**Landscape and Visual (L&V) Monitoring Report for
Harbour Area Treatment Scheme Stage 2A
(Operational Phase) (August 2022)**

Report No.: OT_2022011

Landscape and Visual Impact Assessment Checklist for Site Audit – North Point PTW

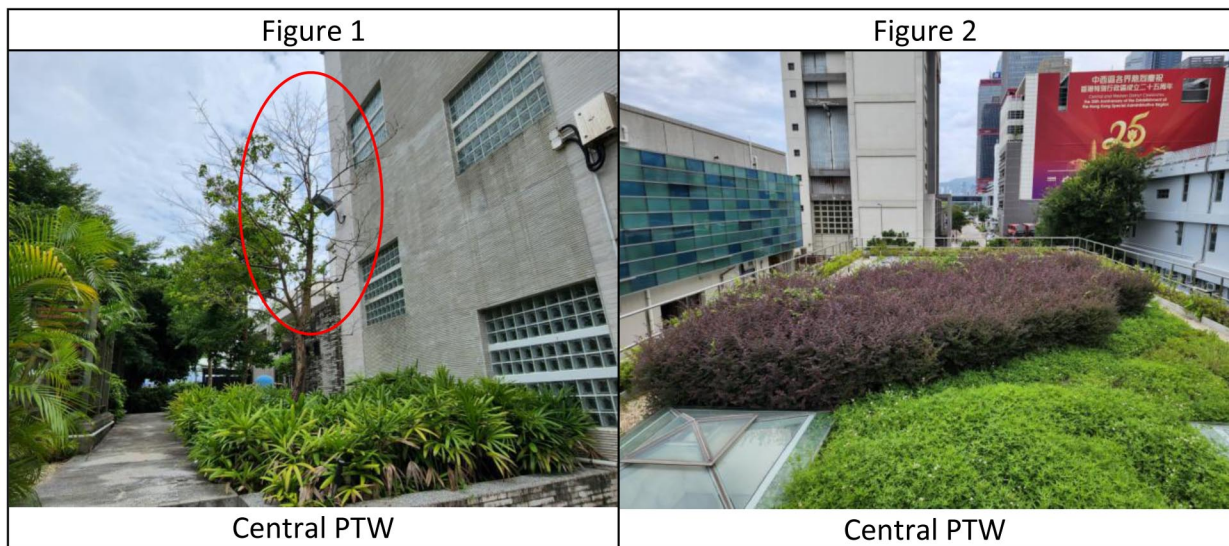
1. Contractor was reminded to keep maintenance and pay attention to the plant conditions on the marked tree (Figure 1) and recommended to further increase the frequency of watering in the period of extreme hot weather.

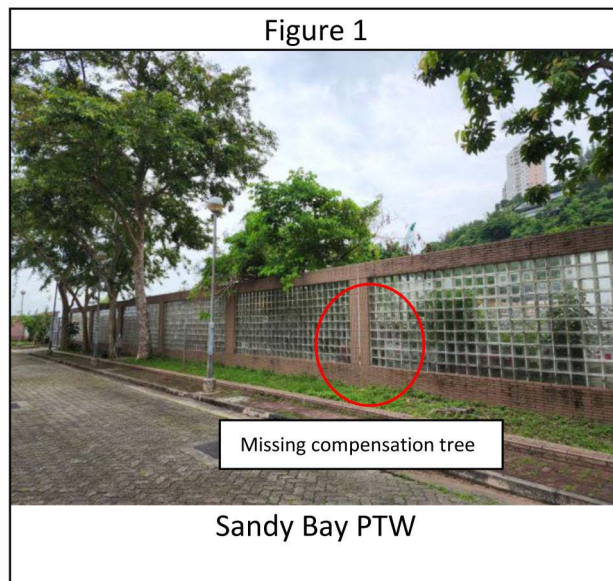
1. Follow up rectification item no.1 on 29/07/2022, the marked tree was removed but the compensation tree is missing. The Contractor is reminded to carry out tree replacement.

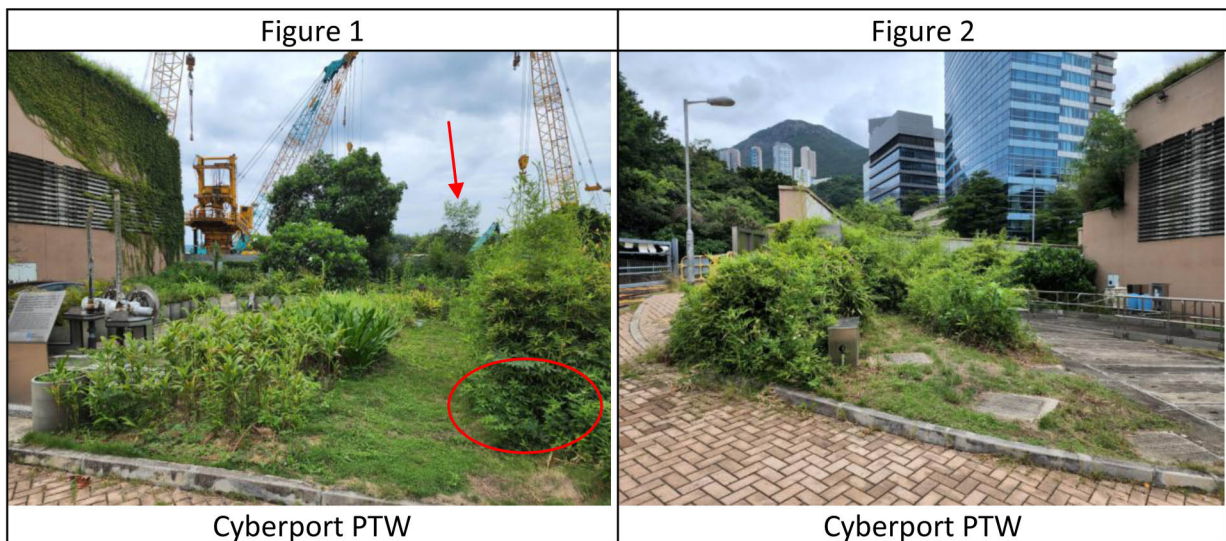
1. Weeds and undesirable species (*Leucaena leucocephala*) were observed among shrubs planting. It is recommended to carry out necessary weeding and maintenance work.

<p>Figure 1</p> 	<p>Figure 2</p> 
<p>Wah Fu PTW</p>	<p>Wah Fu PTW</p>
<p>Figure 3</p> 	
<p>Wah Fu PTW</p>

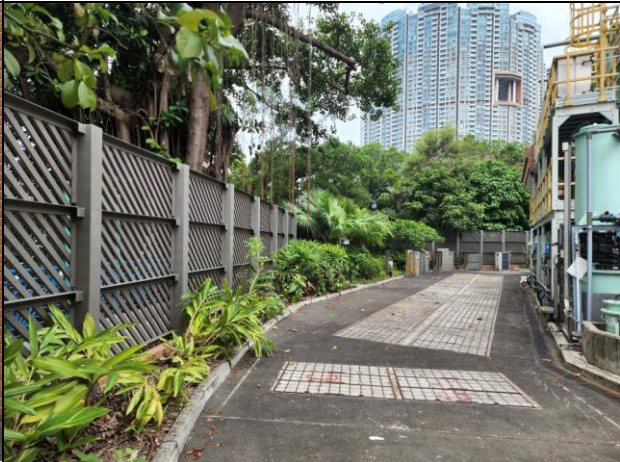
1. Dead leaves were observed at the marked tree (as shown in Figure 3). It is recommended that maintenance party to review if pruning is required.

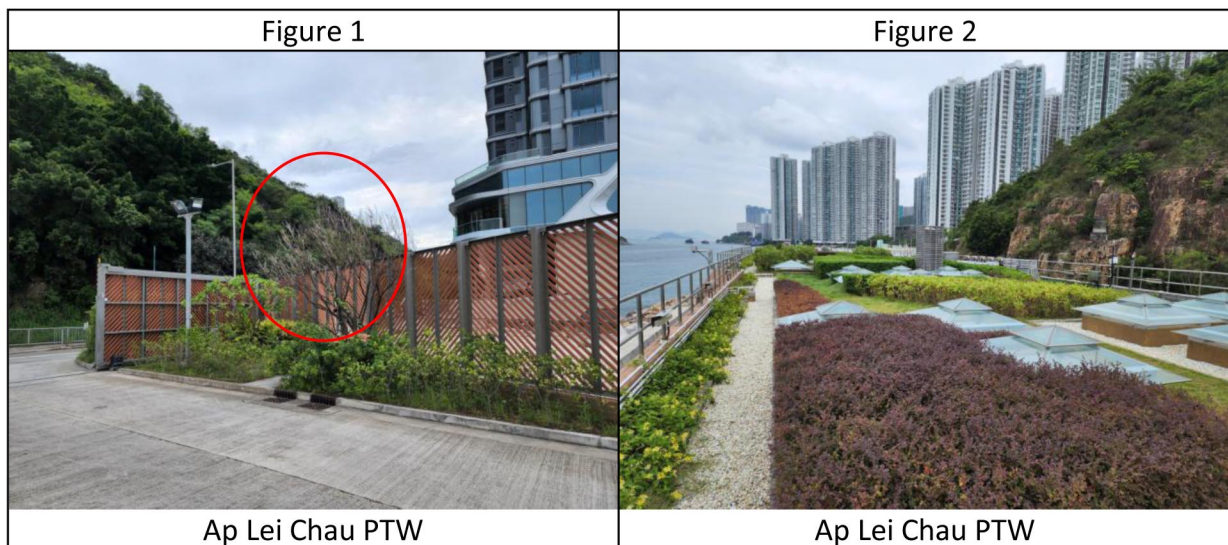
1. Dead tree was observed at entrance area (shown in Figure 1). It is recommended that maintenance party to review if replacement is required.
